RS-13-151

LaSalle County Station, Units 1 and 2
Facility Operating License Nos. NPF-11 and NPF-18
NRC Docket Nos. 50-373 and 50-374

Subject: Response to Request for Additional Information Related to License Amendment Request to Technical Specification 3.7.3, "Ultimate Heat Sink (UHS)"

ATTACHMENT 1
Response to Request for Additional Information

Figure 1: Detail of Mesh at Inlet Boundary (Perspective Side View)

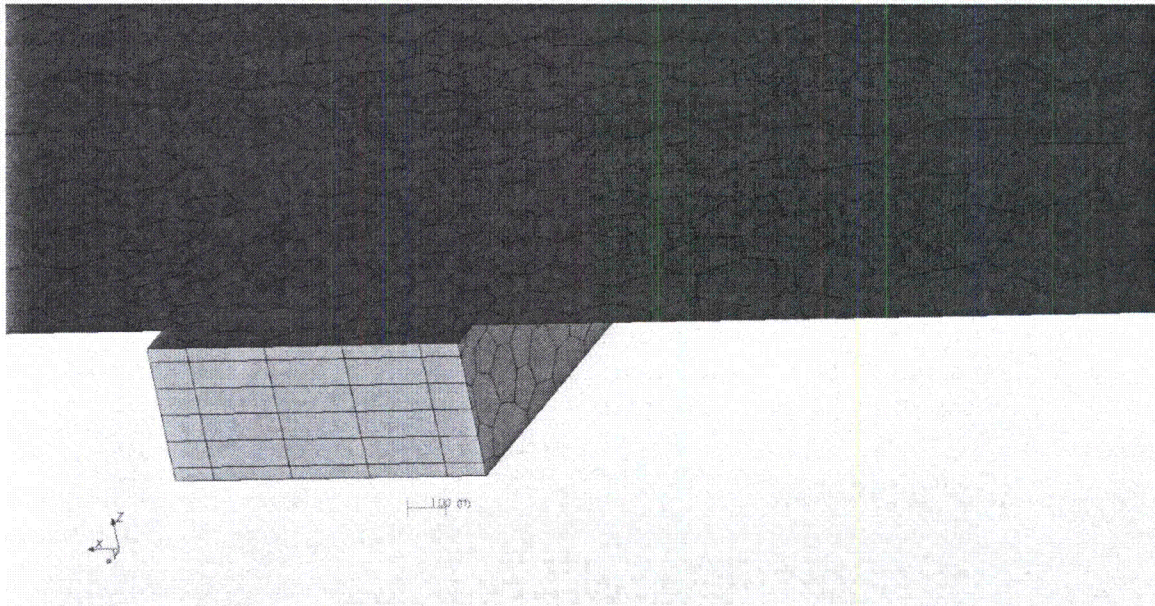
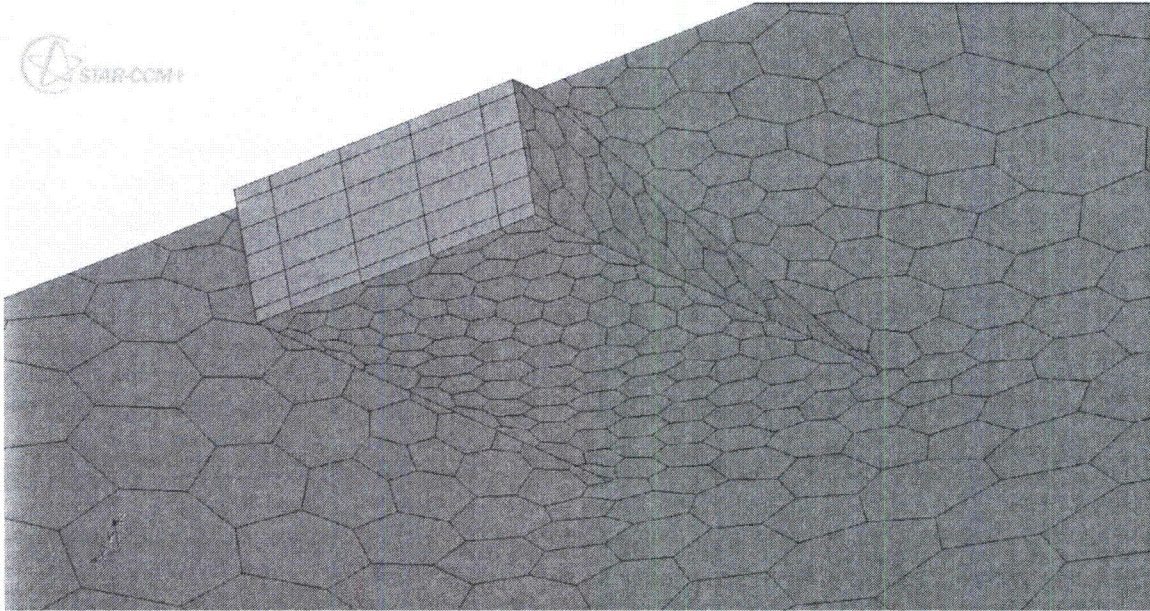
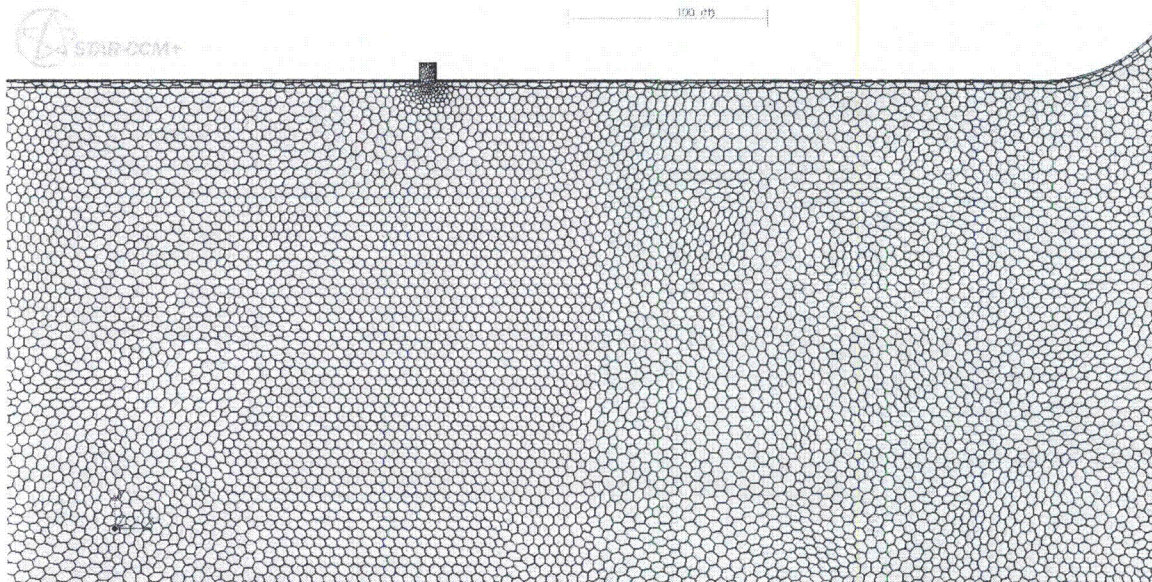
- a. Please discuss the accuracy of the CSCS outfall structure discharge modeling and its effect on mixing in the entrance of the CSCS cooling pond (e.g., nodalization, exit velocities, surface roughness).
- b. Please provide, on scale, figures of fluid velocity in the entrance region including both surface and mid-plane elevations.
- c. Please estimate the percentage of water returning (of total CSCS flow) in each recirculation loop. Please estimate the mean return period for each recirculation loop.
- d. Justify the use of constant density fluid given that thermal stratification may shorten the effective transit time across the UHS. Additionally, how do water temperatures higher than 100°F affect the analysis results (e.g., fluid viscosity)?
- e. To credit diurnal effects, please demonstrate that entrance mixing has no effect on the timing and magnitude of peak UHS temperatures.

The LSCS UHS outfall structure (plant discharge to UHS) is shown in Attachment 4 (Reference 4, LSCS Drawing S-79). The UHS outfall flow path is designed to mitigate entrance turbulence by allowing the return water to flow over a weir with an eight foot wide inclined channel (less than 30°) to the UHS which minimizes inlet mixing at the entrance. The intent of the CFD model was not to investigate local inlet induced turbulence, but to quantify the UHS effectiveness. The CFD analysis included the eight foot wide outfall structure interface to the UHS with the design cooling water flow rate of 86 ft³/s (38,600 gpm). This feature was modeled in the CFD analysis that determines the effectiveness of the LSCS UHS. Figures of the nodalization of the inlet boundary are provided in Attachment 3 (Attachment J, Appendix J8.6) and are shown below in Figures 1 through 3. The inlet velocity of the water is equal to approximately 3.1 ft/s, which corresponds to 86 ft³/s and indicates accurate modeling of the inlet water velocity based on the dimensions of the discharge channel and the UHS depth. The surface roughness of the bottom of the UHS (including the silt layer), based on the calculated UHS low water velocities, does not significantly affect the results of the analysis, which are the overall water flow pattern and speed within the UHS.

Figure 11: UHS Heat Load

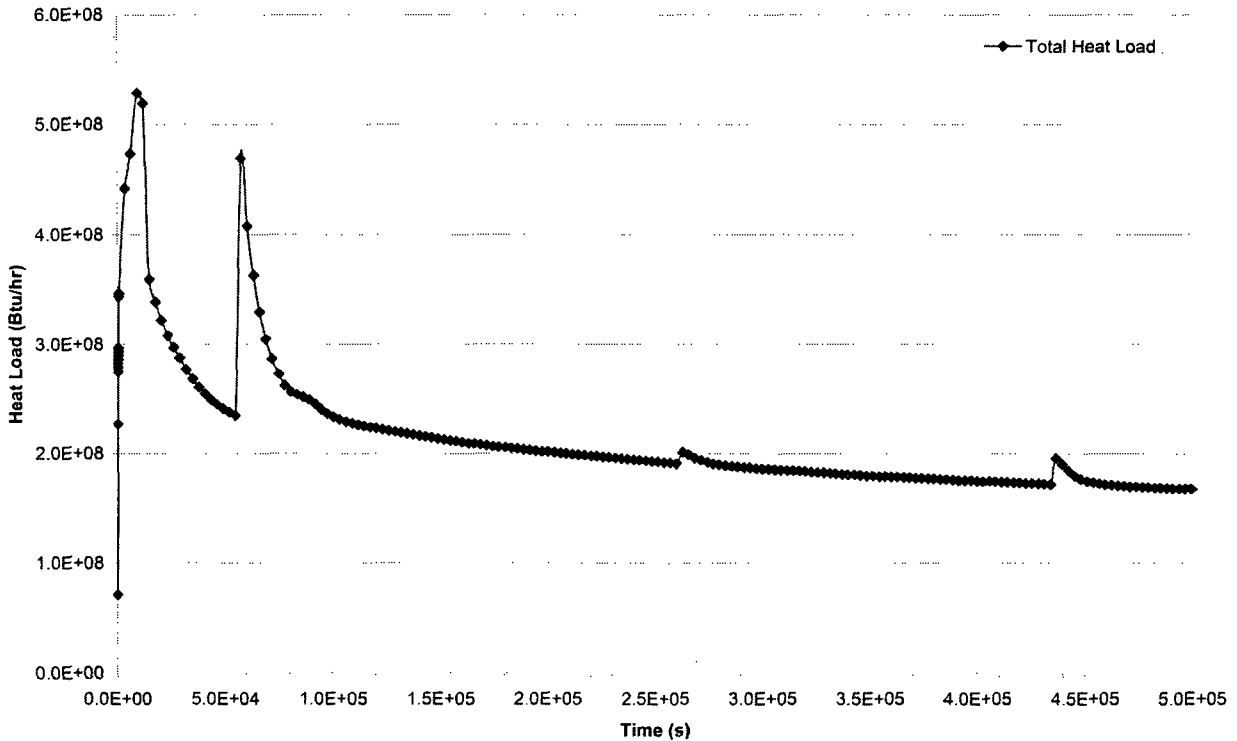
- a. Please provide the heat loads calculations to be relied on for the TS limit safety basis (i.e., by the letter dated July 12, 2012, or February 11, 2013).
- b. Please provide heat loads for fully loaded spent fuel pools, and describe any appropriate considerations and allowances for post-shutdown time for all fuel.
- c. Please confirm that peak heat rejection rates are consistent with plant shutdown allowable under LSCS's emergency operating procedures and any other operational requirements.
- d. Please provide justification that any variation in the timing of peak heat load will not affect the proposed TS curve.

Attachment D of Attachment 5 contains the heat load calculations to be relied upon for the TS limit safety basis. These heat loads are input to the LSCS UHS analysis (Attachment 3) to determine the peak plant cooling water inlet temperature. The analysis maximizes heat rejection from the plant using all available RHR heat exchangers. The overall heat load is comprised of decay heat from both units, decay heat from the spent fuel pools of both units, sensible heat, and associated safety equipment. Figure 11 below shows the first 500,000 seconds to emphasize peak values (which occur at the beginning of the event) in the plot.

Figure 13: Hourly Average Wind Speed Exponent at LSCS Meteorological Tower

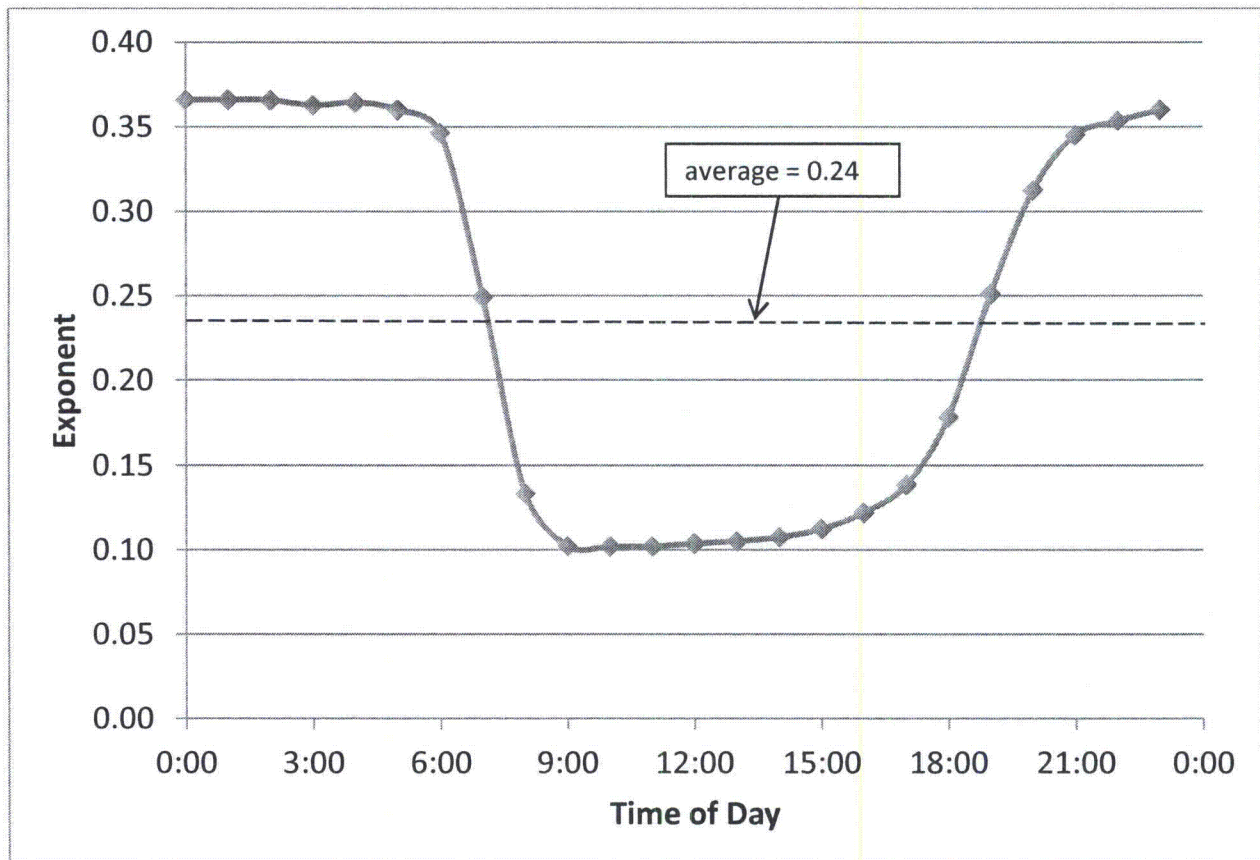
- a. Please calculate and provide a discussion of the average exponent coefficients by hour of the day for the summer months of June, July, and August, from 1995 through 2009.

The average exponent coefficients were calculated by hour of day for the summer months of June, July, and August from 1995 through 2009 using the on-site meteorological tower wind speed at the measurement heights of 33 ft and 200 ft in the power law equation. The average wind speed exponent is 0.24, being lower during the day for unstable atmospheric conditions and higher at night during stable conditions, is shown in Figure 13.
